## MITIGATION PLAN

**Round Hill Branch Restoration Site  
Buncombe County, North Carolina  
DMS Project Number 100066  
DEQ Contract 7534  
USACE AID #: SAW-2018-01168  
NC DWR#: 20181031 v1**

Subject: Round Hill Branch Restoration Site  
Mitigation Plan Review – Response to IRT Comments  
French Broad River Basin - 06010105  
Buncombe County, North Carolina  
DEQ Contract No. #7534  
DMS Project #100066  
USACE AID #: SAW-2018-1031 v1

Subject: Round Hill Branch Restoration Site  
Draft Mitigation Plan Review  
French Broad River Basin – CU# 06010105  
Buncombe County  
DMS Project ID No. 100066  
Contract # 7534

**FIGURE 3. PROJECT SITE/TLW WATERSHED MAP  
 ROUND HILL BRANCH RESTORATION SITE  
 BUNCOMBE COUNTY, NC**

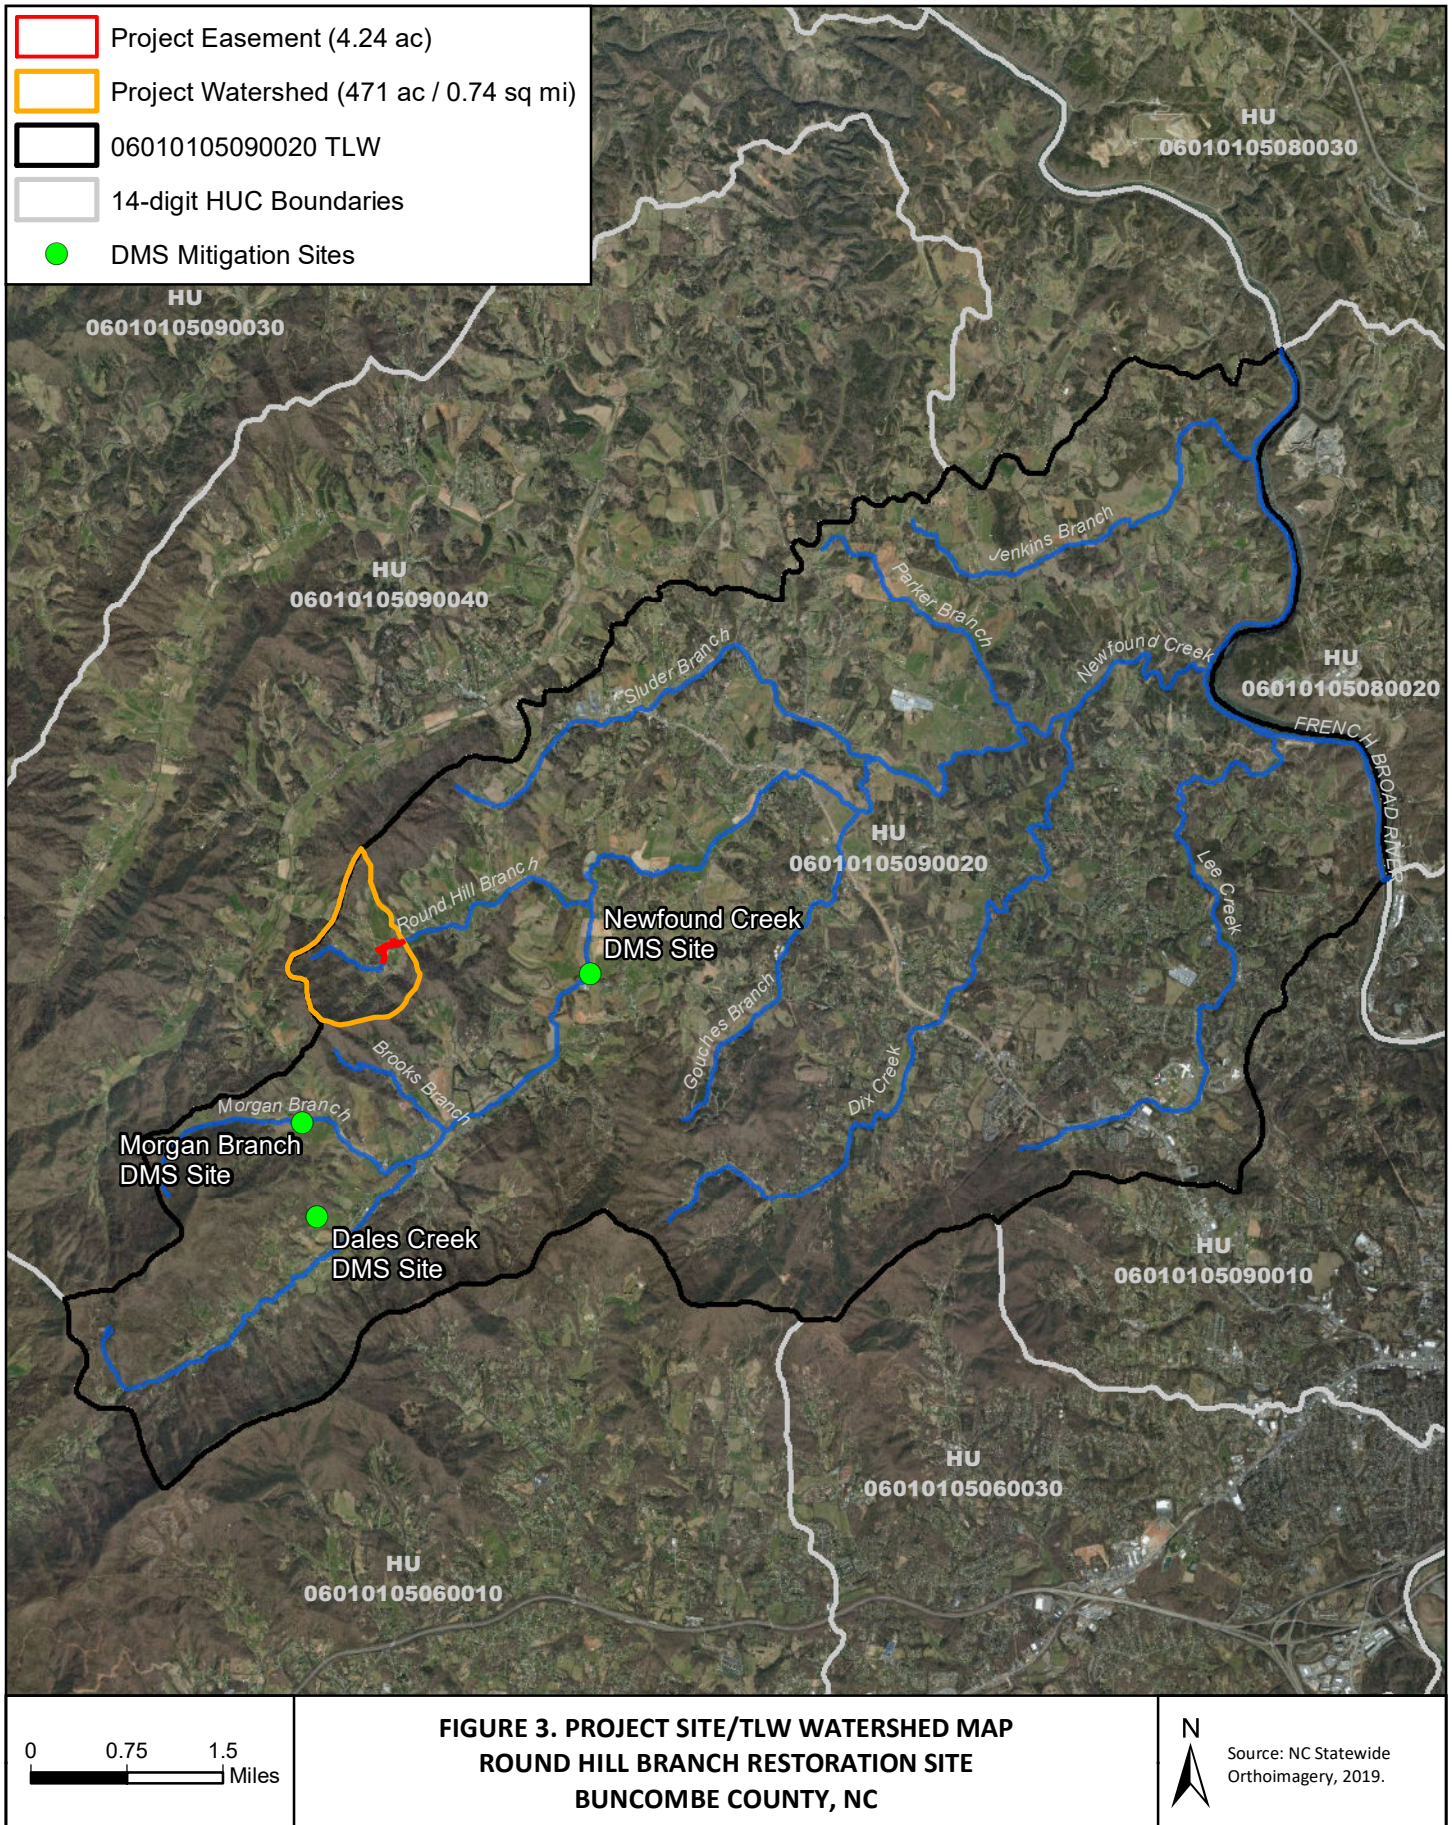
**Figure 3:**

Please use points or conservation easement shape files for the three additional DMS sites listed on the Figure instead of the symbols currently selected.

FIGURE 7. CURRENT CONDITIONS  
 ROUND HILL BRANCH RESTORATION SITE  
 BUNCOMBE COUNTY, NC

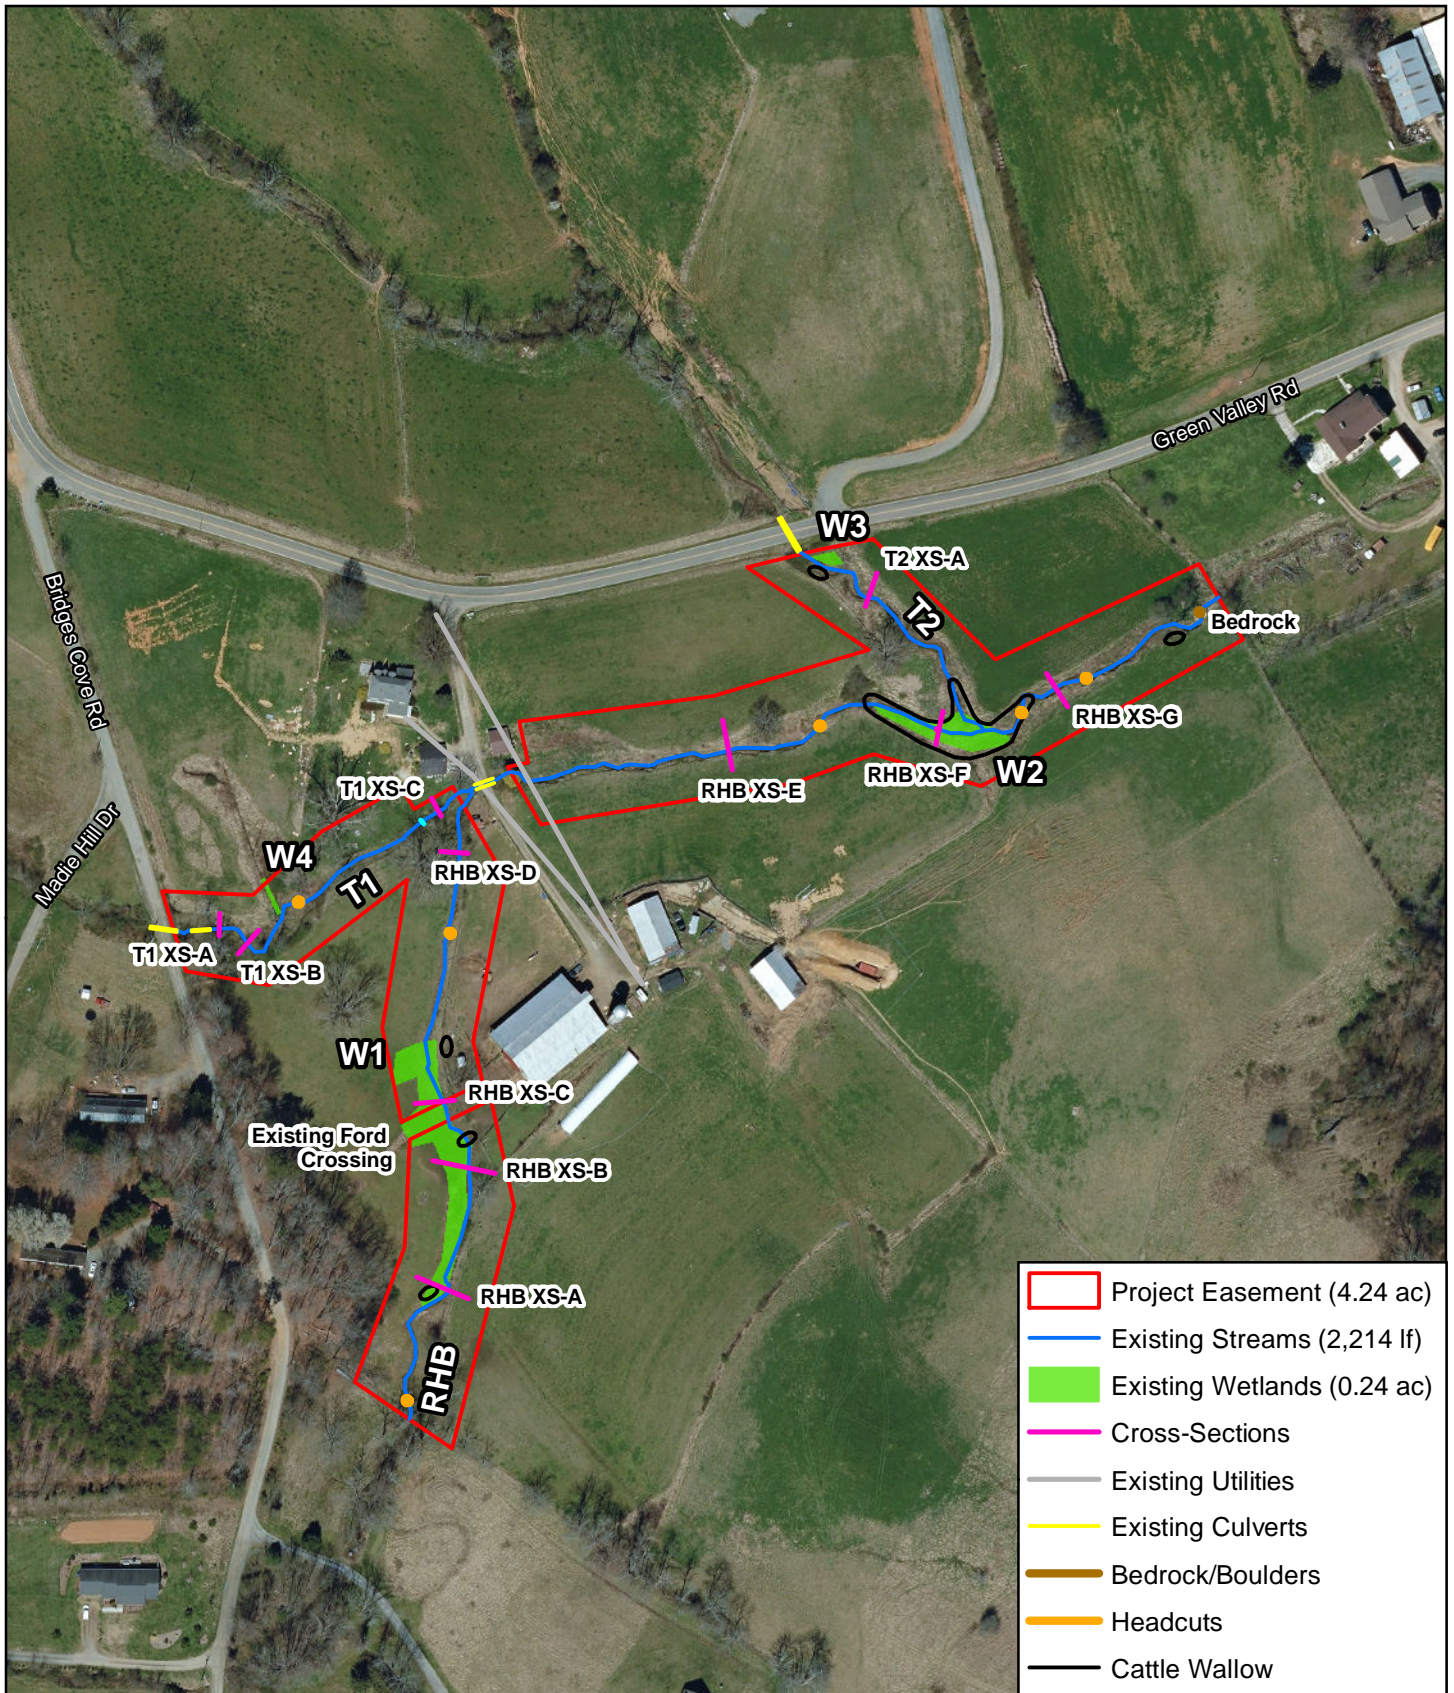
Page 11: A small headcut is described as “just past the property line”. It is unclear if this headcut is on the RHBR property or adjoining property. Please clarify. If it is off the property, does KCI have permission to address and stabilize the headcut during construction?

**Figure 7:**

*The headcut is located about 15 feet within the property. The wording had been changed and the headcut is now shown in Figure 7.*

*These have been added to the figure.*

**FIGURE 8. PROJECT ASSET MAP**  
**ROUND HILL BRANCH RESTORATION SITE**  
**BUNCOMBE COUNTY, NC**

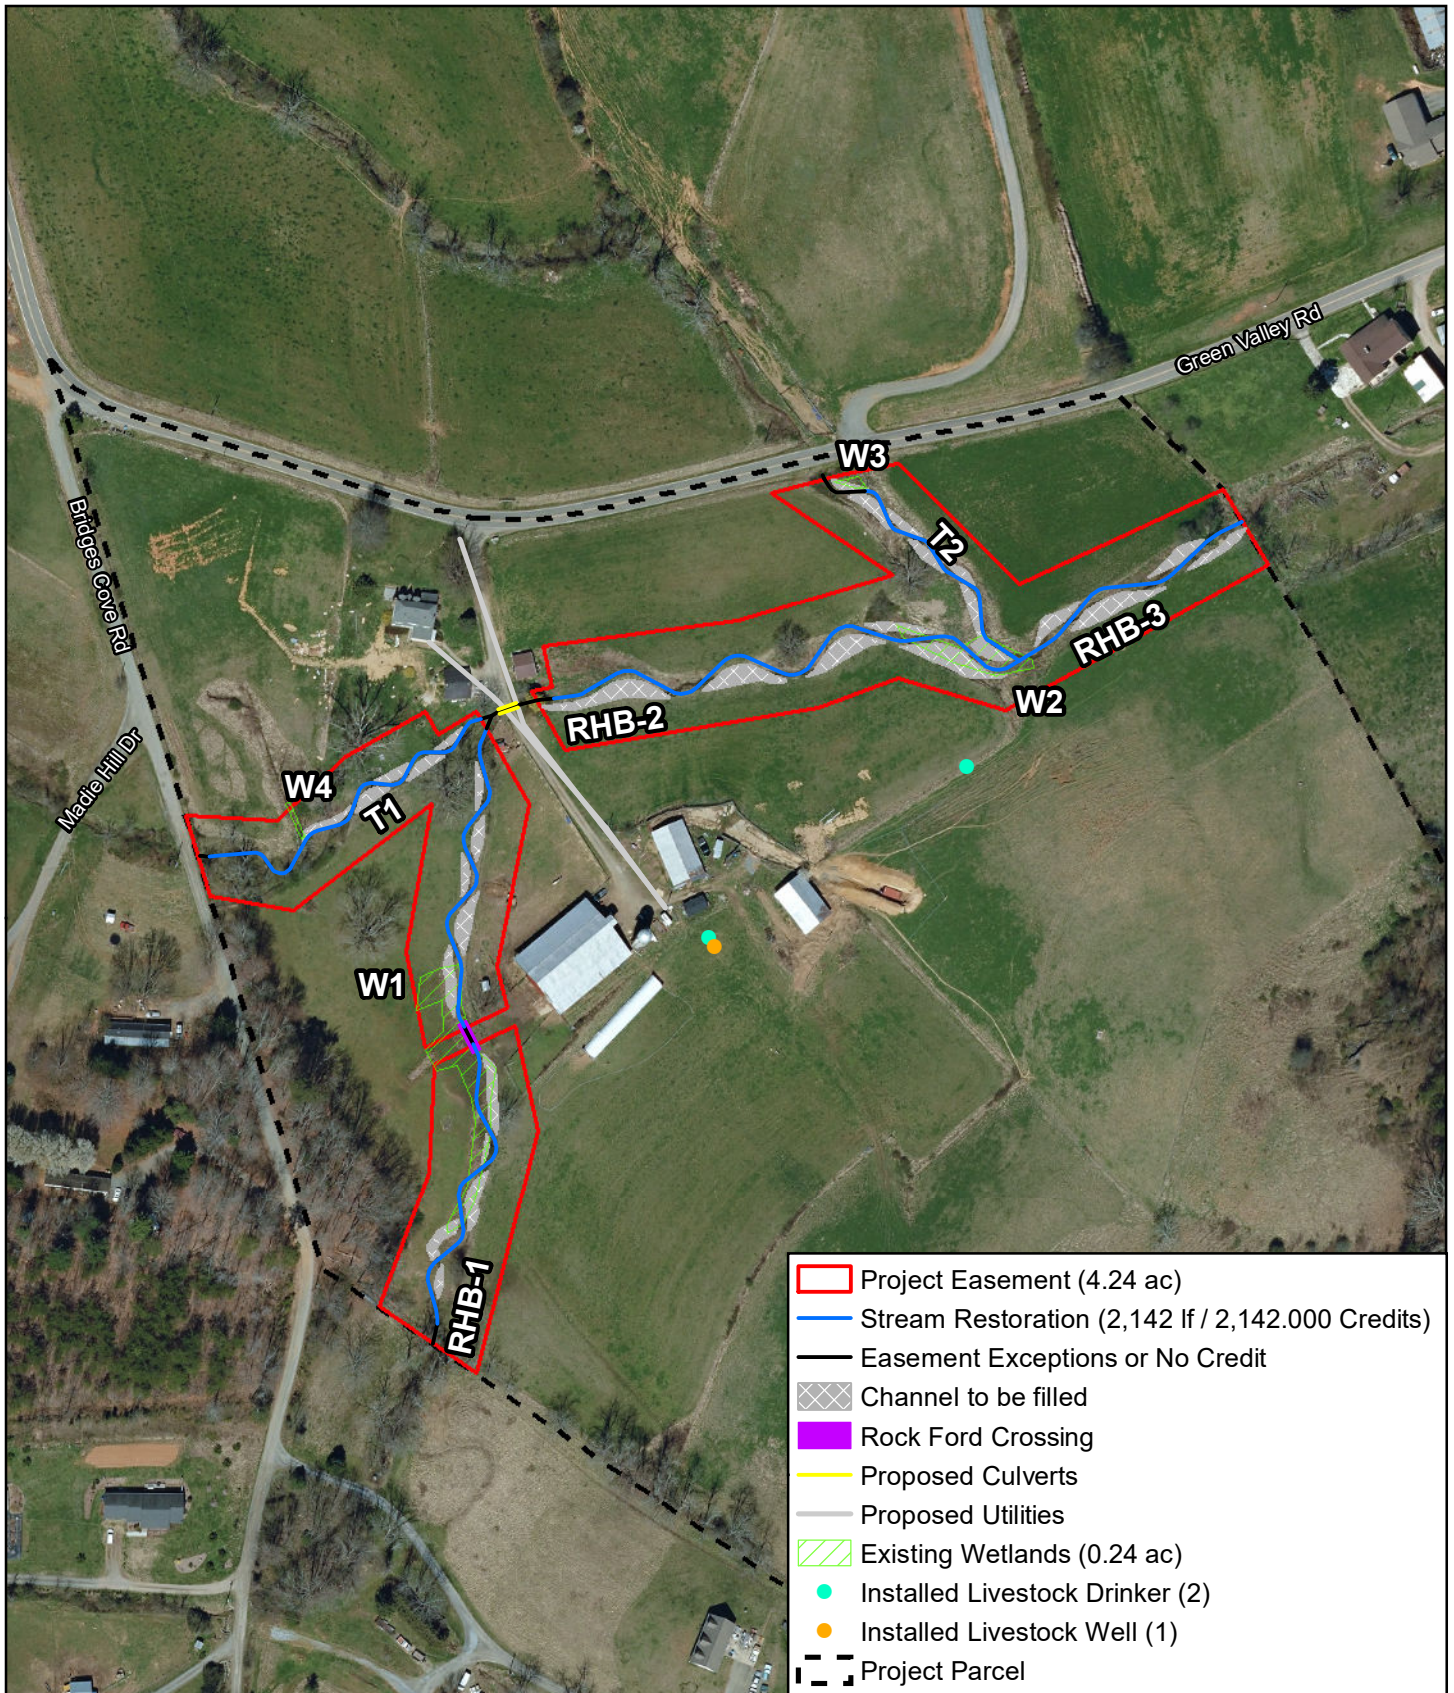
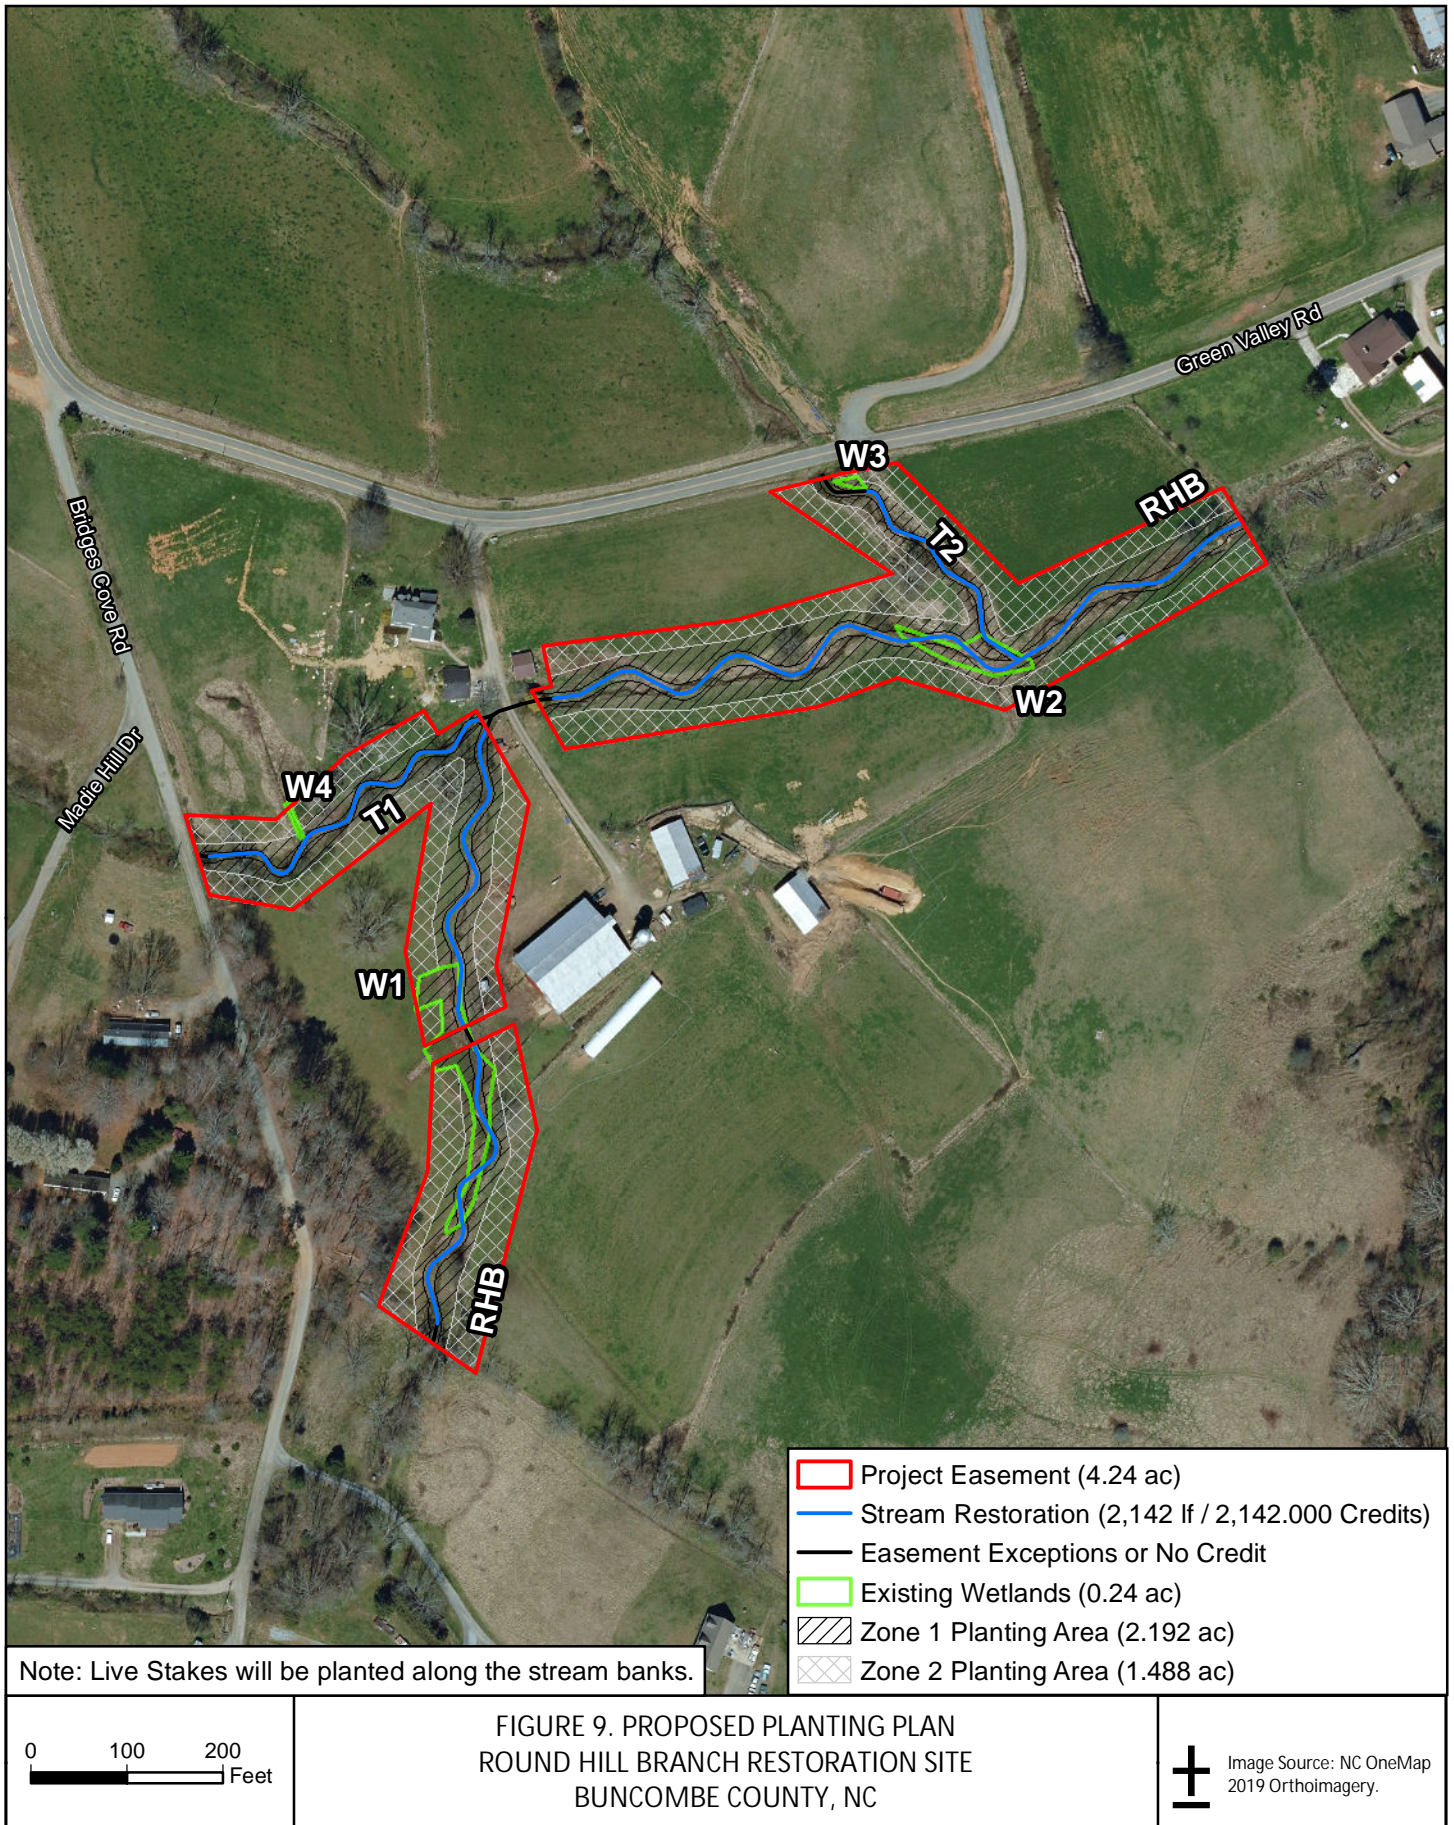
**Figure 8 and 9:**

Please show existing wetlands on these figures and all future figures including CCPV.

*The existing wetlands have been added to these figures.*
